Project	IEEE 802.16 Broadband Wireless Access Working Group < http://ieee802.org/16 >	
Title	Proposal for Changing 16i chapter 1.3.1 Figures	
Date Submitted	2006-05-10	
Source(s)	Zou Lan / Huawei Jörg Schmidt / Motorola Joey Chou / Intel	Mailto: zlan@huawei.com j.Schmidt@Motorola.com joey.chou@intel.com
Re:	Contribution to IEEE 802.16i	
Abstract	This contribution proposed to replace 16i chapter 1.3.1 Figure 2 and Figure 3 and add corresponding descriptions on figure1, figure2&3.	
Purpose	Adoption	
Notice	This document has been prepared to assist IEEE 802.16. It is offered as a basis for discussion and is not binding on the contributing individual(s) or organization(s). The material in this document is subject to change in form and content after further study. The contributor(s) reserve(s) the right to add, amend or withdraw material contained herein.	
Release	The contributor grants a free, irrevocable license to the IEEE to incorporate material contained in this contribution, and any modifications thereof, in the creation of an IEEE Standards publication; to copyright in the IEEE's name any IEEE Standards publication even though it may include portions of this contribution; and at

Figure 2—Mobile BWA Network Management Architecture – Context A

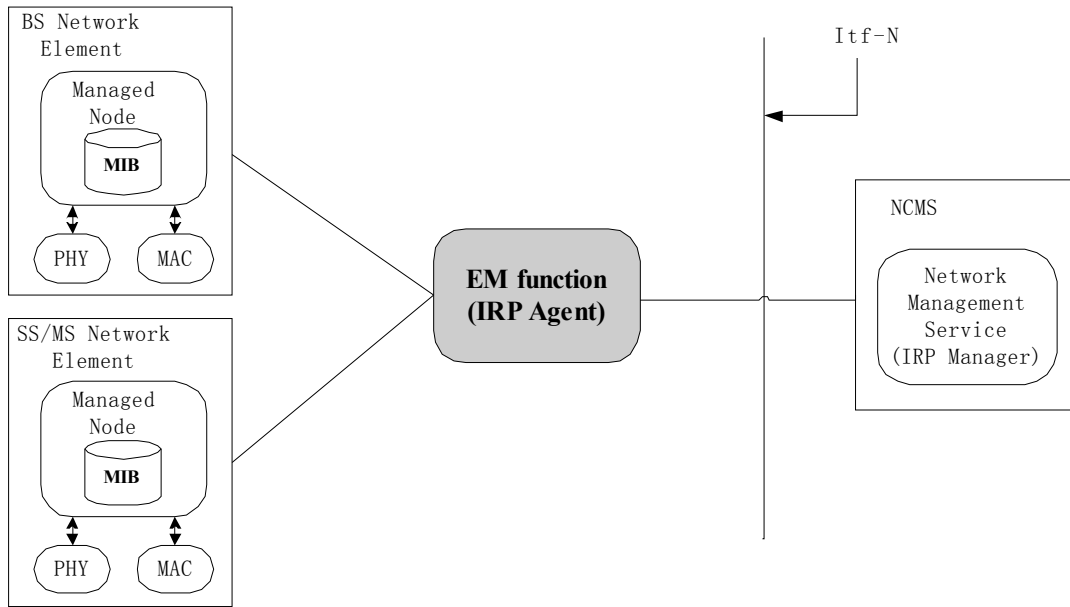
Figures 2 and 3 identify system contexts of the Management Interface “2” in terms of its implementation, called IRPAgent, and the user of the IRPAgent, called IRPManager (for a definition of IRPManager and IRPAgent see [2]). An NE can be managed either
via System Context A (element management function and IRP Agent are a standalone system) or
via System Context B (element management function and IRP Agent embedded within the NE).

The criterion for choosing System Context A or B to manage a particular NE is implementation dependent. An IRPAgent shall support one of the two System Contexts.

Replace chapter 1.3.1 Figure 2 as following:

Figure 3—Mobile BWA Network Management Architecture – Context B

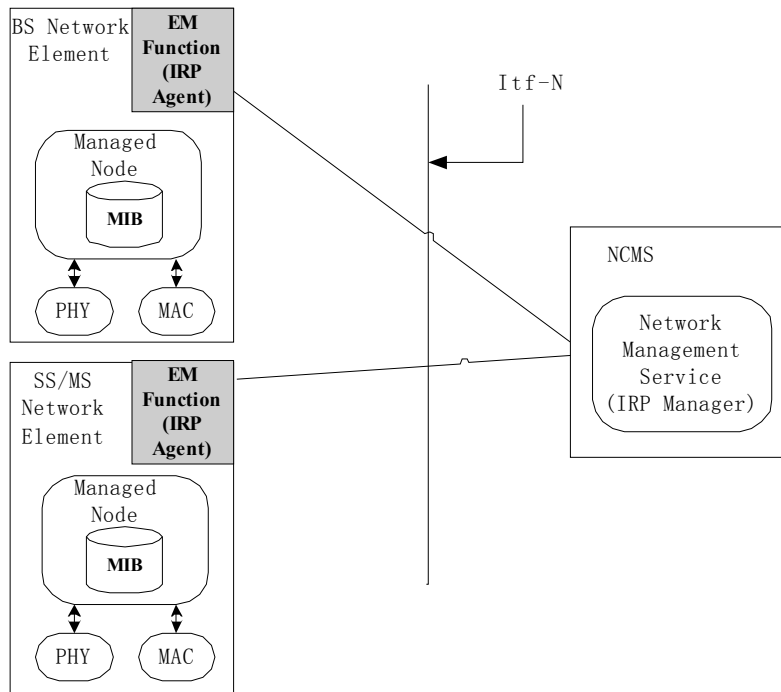
Replace chapter 1.3.1 Figure 3 as following:
